## **Mcpherson, Benjamin J (DEC)**

**Subject:** RE: Site 108 Wetland Sampling Optimization

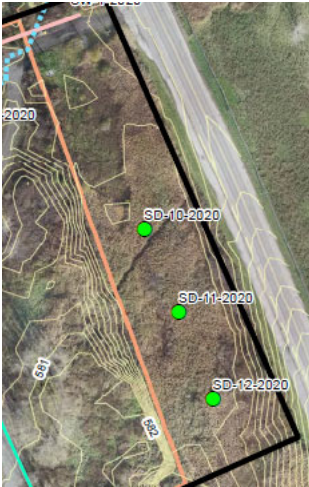
The original WP specified collection of the 3 sediment cores shown below. The 3 wells/piezometers were added subsequent to the final WP (12/20/20 email). The WP and subsequent email specifies the following for sediment core and well/piezometer soil sampling:

- Well/piezometer soil sampling. Soil samples will be collected at 0 to 2 inches and 2 to 12 inches below grade. An additional sample will be collected in the 1-foot interval beneath tar, if present. If tar is not present, a sample will be collected from elsewhere in the boring that exhibits signs of contamination (i.e. staining, elevated PID reading, etc.). All samples will be analyzed for SVOCs and TOC. Samples from the 3 new locations will be analyzed for the full suite of analyses including TCL VOCs, SVOCs, and pesticide/PCBs, TAL metals, cyanide, and PFAS.

- Sediment core sampling. Samples will be collected using a slide hammer and macrocore Lexan liner to a maximum of 5 ft bgs or until native material is encountered. Sampling methods, locations, and total depths are subject to change based on an inspection of the current conditions at sampling locations. Samples will be collected in 6-inch intervals up to 1 ft bgs, and in 1-foot intervals from 1 to 5 ft bgs or until native material is encountered, whichever comes first. If native material is encountered, a sample will be collected from the top 1 ft. Cores will be visually assessed, photographed, screened with a PID, and observations will be documented in a field log. Samples will be analyzed for TCL VOCs, SVOCs (including the 34 PAHs specified in NYSDEC 2014),

pesticide/PCBs, TAL metals, cyanide, TOC, and PFAS. After sampling, the location of each sample location will be surveyed.

Wetland Area

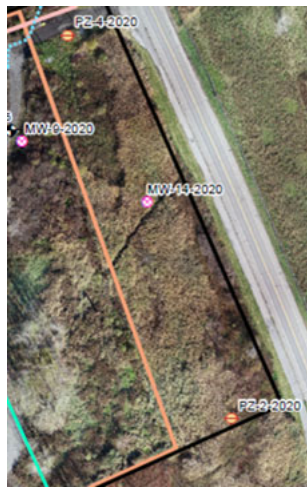
Given the proximity of MW-14 and PZ-2 to the wetland sediment cores, we propose modifying the scope as follows.

- Sampling and analysis of MW-4 and PZ-2 consistent with the sediment core rather than the well/piezometer soil approach. However, consistent with the soil sampling strategy, for the soils deeper than 5 feet, an additional sample will be collected in the 1-foot interval beneath tar, if present. If tar is not present, a sample will be collected from elsewhere in the boring if it exhibits signs of contamination (i.e. staining, elevated PID reading, etc.).
- Eliminating sediment core locations SED 10 and SED 20 (replaced with the sampling above)
- Moving sediment core location SED 11 so it is equal distance between MW-14 and PZ-2, and having the drillers collect the core using a split spoon

My understanding of the proposed modification is summarized below, with my interpretations in [red]:

- Sampling and analysis of MW-4 [MW-14-2020] and PZ-2 [PZ-2-2020] consistent with the sediment core rather than the well/piezometer soil approach [samples from 0-6", 6-12", 1-2', 2-3', 3-4', and 4-5' all analyzed for TCL VOCs, SVOCs (including the 34 PAHs specified in NYSDEC 2014), pesticide/PCBs, TAL metals, cyanide, TOC, and PFAS]. However, consistent with the soil sampling strategy, for the soils deeper than 5 feet, an additional sample will be collected in the 1-foot interval beneath tar, if present. If tar is not present, a sample will be collected from elsewhere in the boring if it exhibits signs of contamination (i.e. staining, elevated PID reading, etc.) [sample from >5' will be for SVOCs and TOC only].

- Eliminating sediment core locations SED 10 [SED-10-2020] and SED 20 [SED-12-2020] (replaced with the sampling above)
- Moving sediment core location SED 11 so it is equal distance between MW-14 and PZ-2, and having the drillers collect the core using a split spoon [and renamed SED-10-2020. Will be sampled as described in the first bullet to depth of 5' or native soil, whichever comes first].

Also, considering the limited results I have seen from Site 110 and the BCP site I would request that the >5' soil samples from all the monitoring well/piezometer installations also be analyzed for TCL VOCs.
